DOCKETS 50-266 AND 50-301
SUBMITTAL OF REVISION TO
PRESSURE TEMPERATURE LIMITS REPORT
POINT BEACH NUCLEAR PLANT, UNITS 1 AND 2

DESCRIPTION OF CHANGES
PRESSURE TEMPERATURE LIMITS REPORT
POINT BEACH NUCLEAR PLANT, UNITS 1 AND 2

PRESSURE TEMPERATURE LIMITS

REVISION 0

FIGURE 1
RCS PRESSURE-TEMPERATURE LIMITS FOR HEATUP

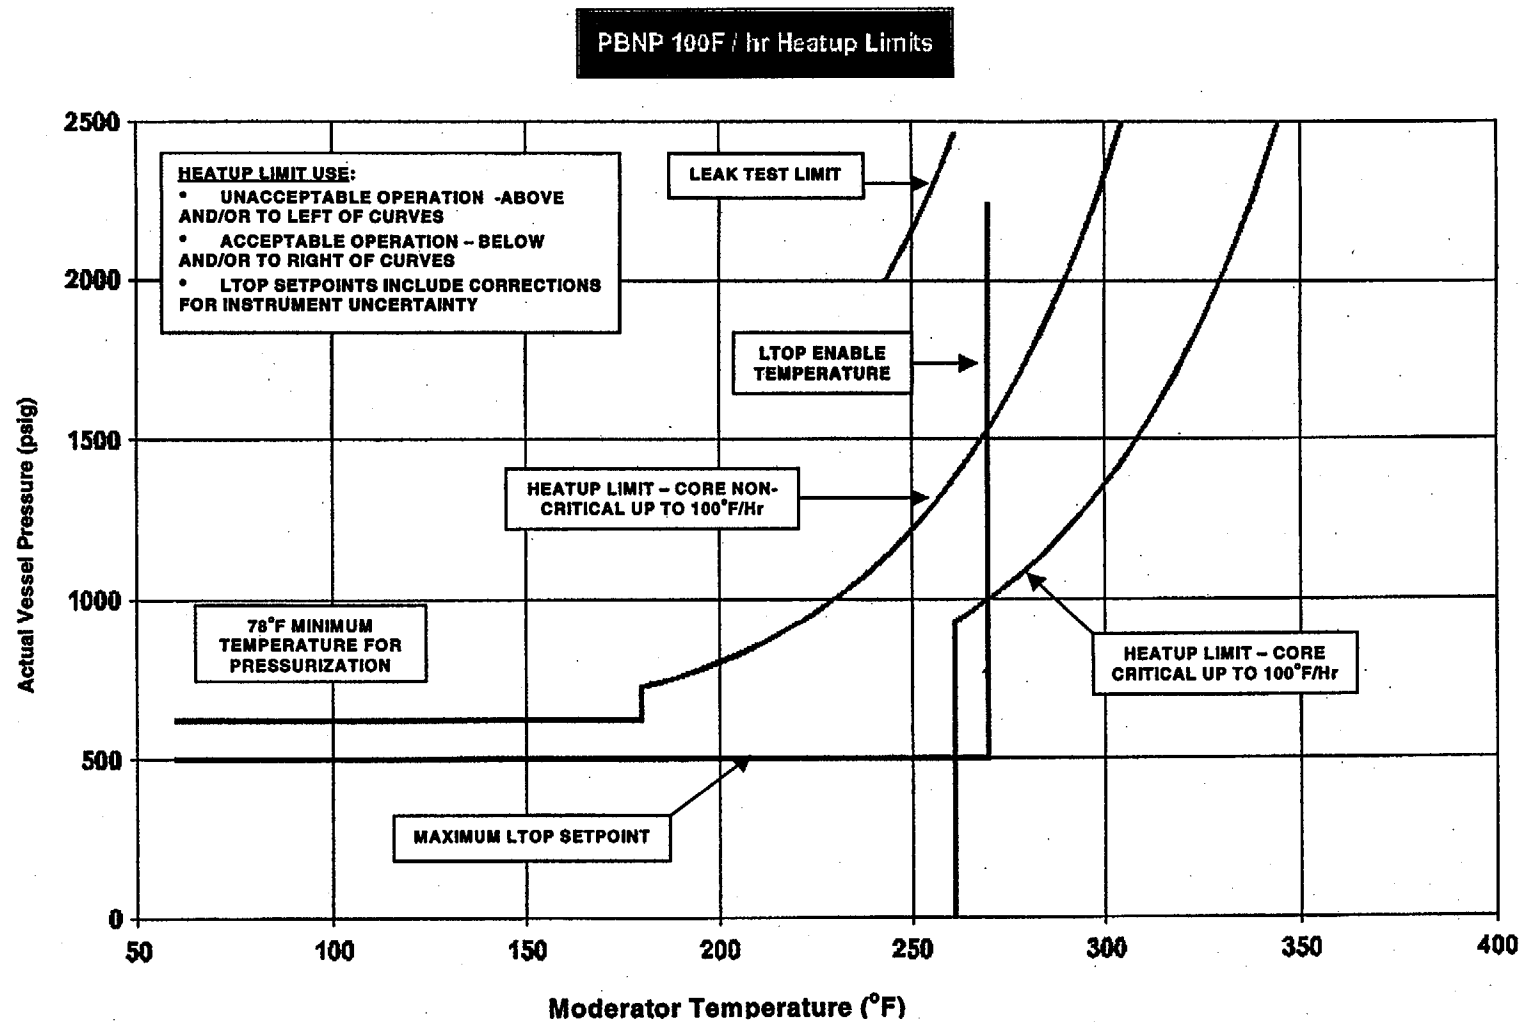
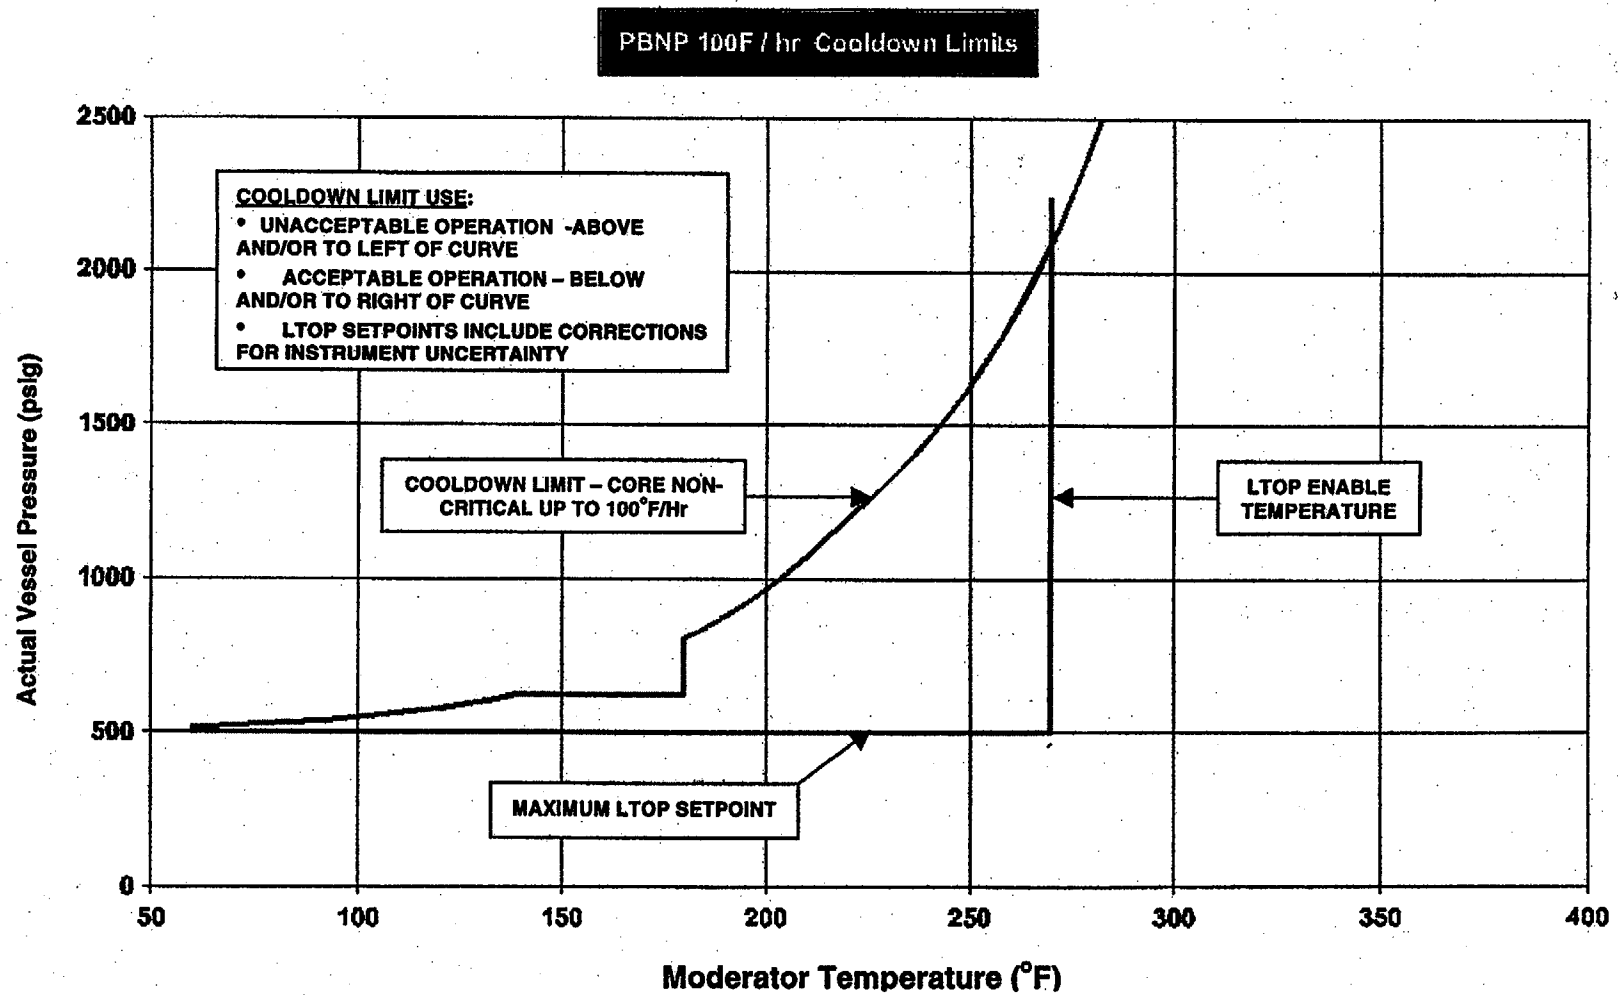
2.1.2 The RCS P-T limits for heatup and cooldown are specified by Figures 1 and 2, respectively (includes instrument uncertainty).

PTLR section 2.1.2 is clarified to specify that instrument uncertainty is included in the value specified for the limit. Section 2.1.3 is changed to reflect that the minimum temperature for

2.1.2 The RCS P-T limits for heatup and cooldown are specified by Figures 1 and 2, respectively (includes instrument uncertainty).
